PCLS Lakewood Interim Library

SITE BID SET – ADDENDUM NUMBER 3

ISSUED: August 21, 2023

C103

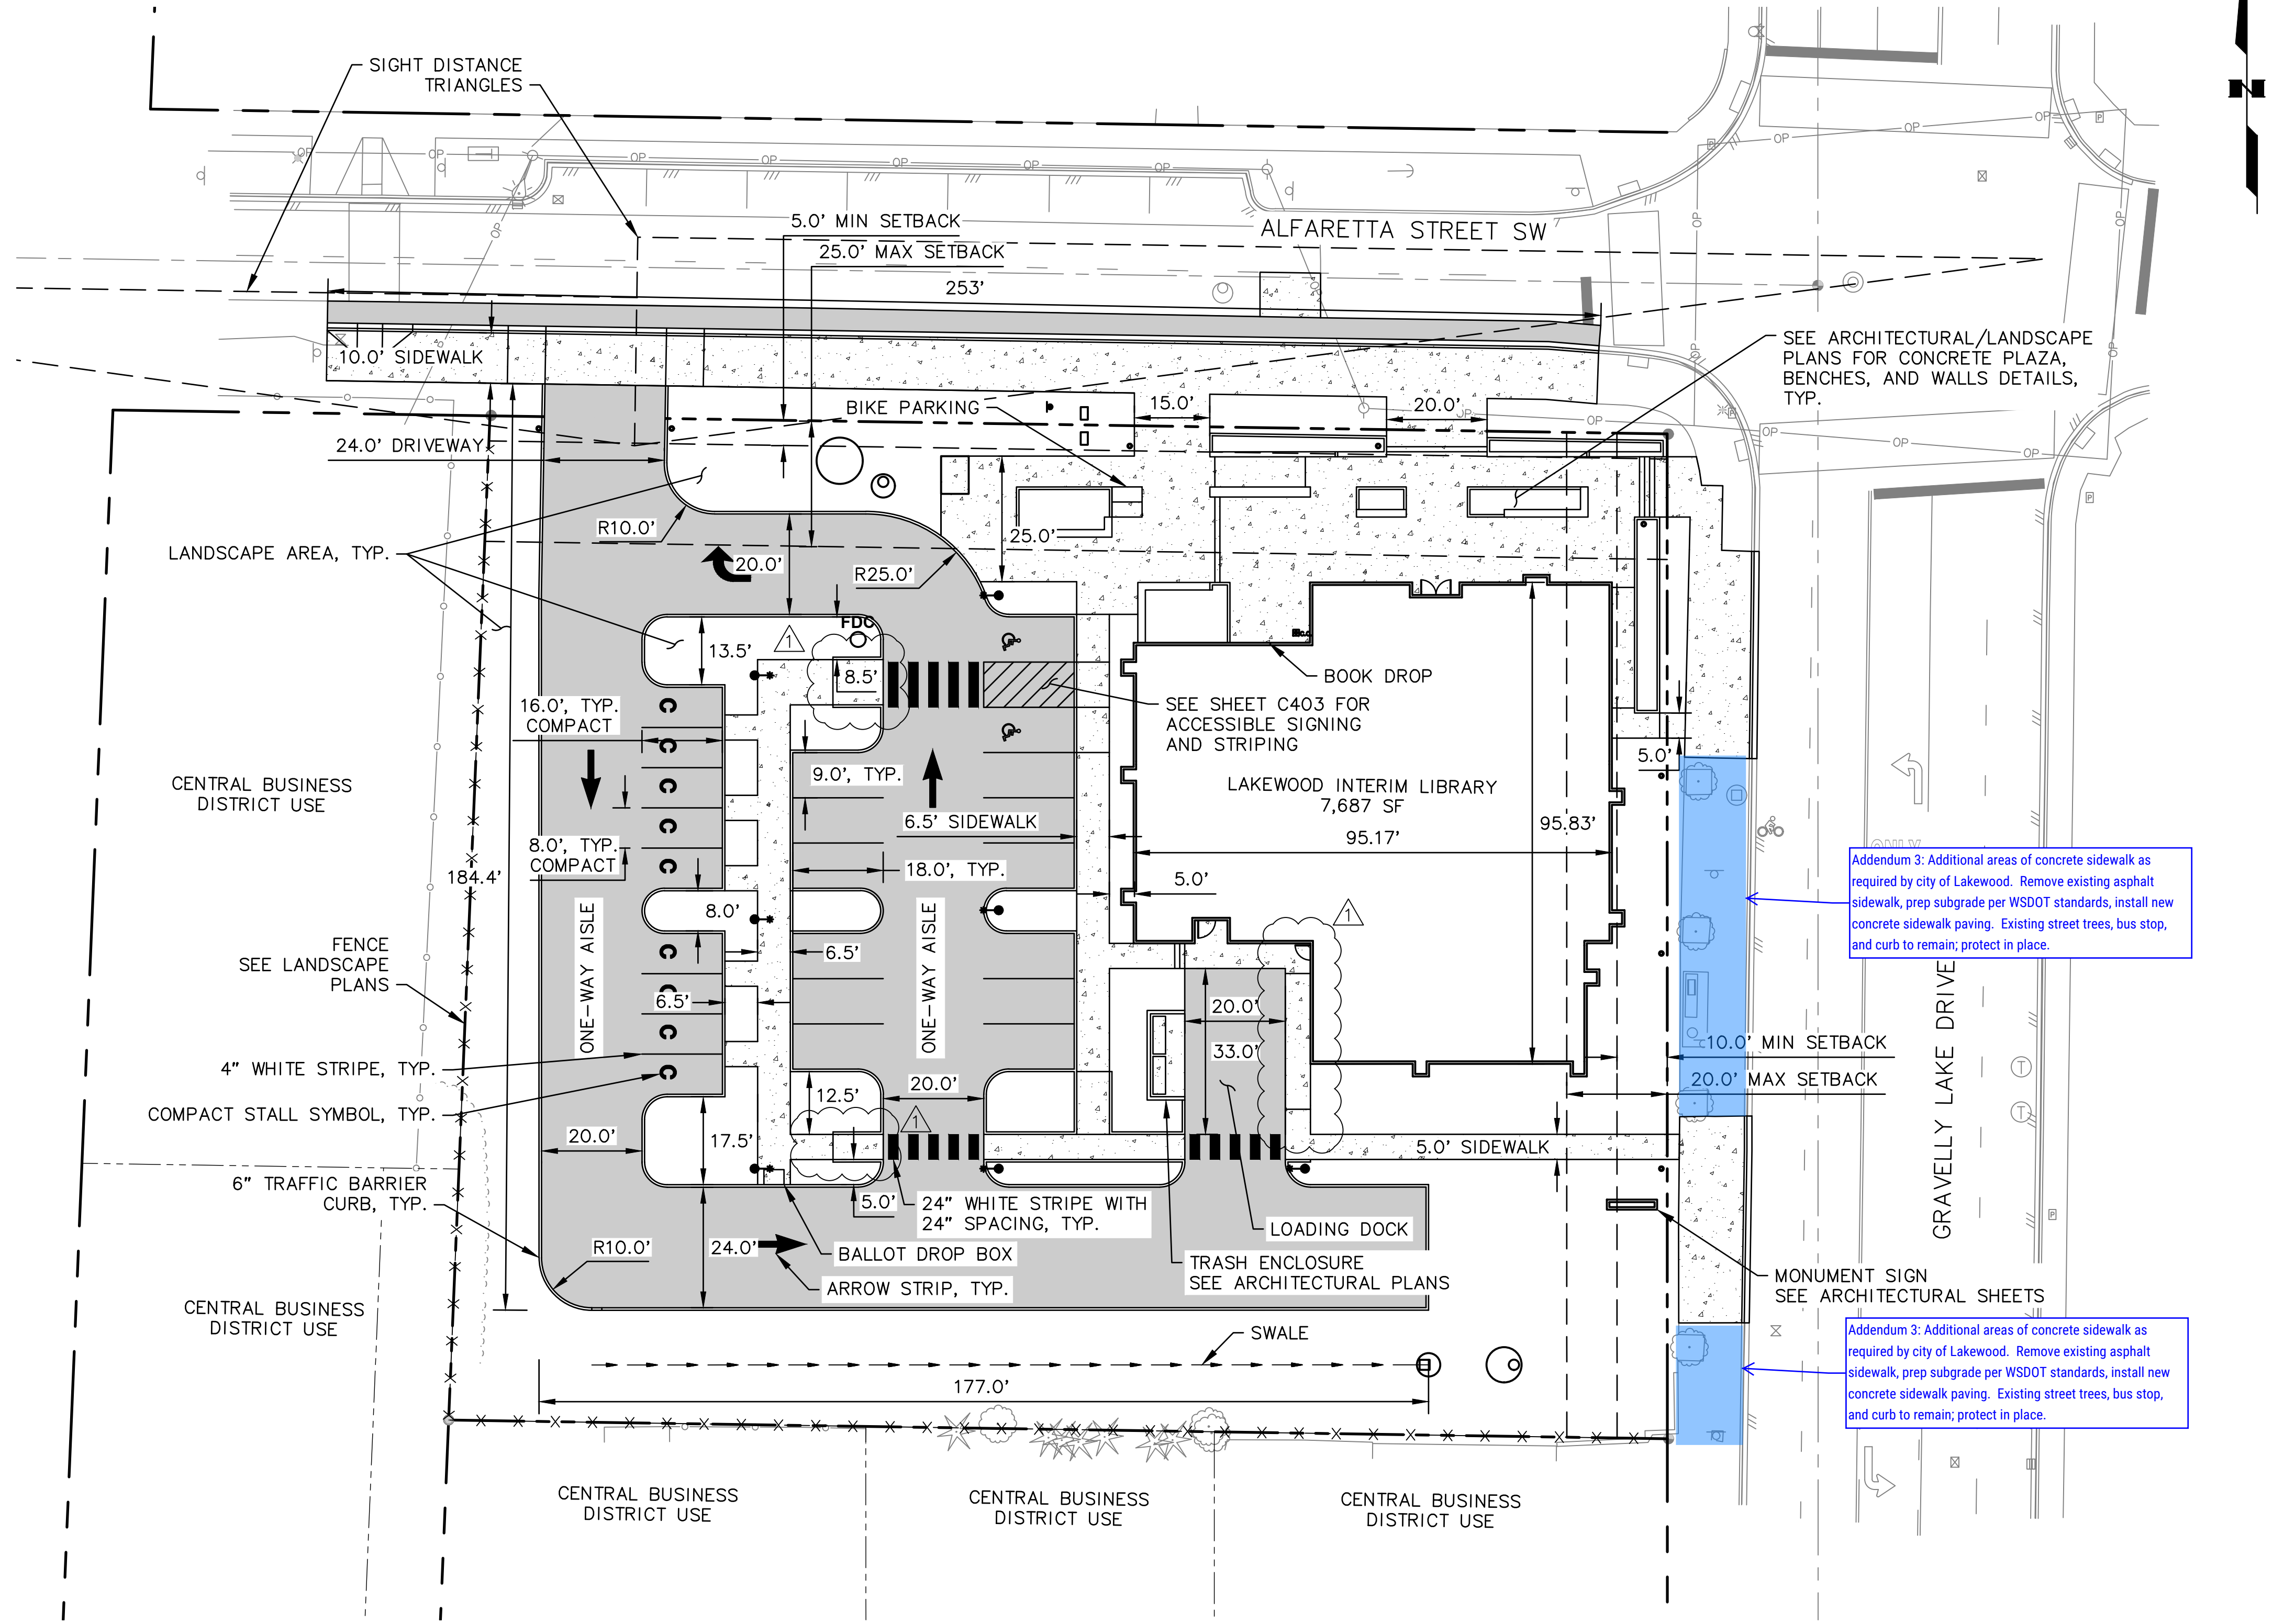
Revision: City of Lakewood is requiring full replacement of existing asphalt sidewalk on Gravelly Lake Road with Concrete per WSDOT standards. Existing concrete curb and street trees to remain. Construction to be per WSDOT standards. See redlines on Sheet C103 for extent of scope.

1 8/11/23 ADDENDUM 1
Redline_8/21/23 Addendum 3
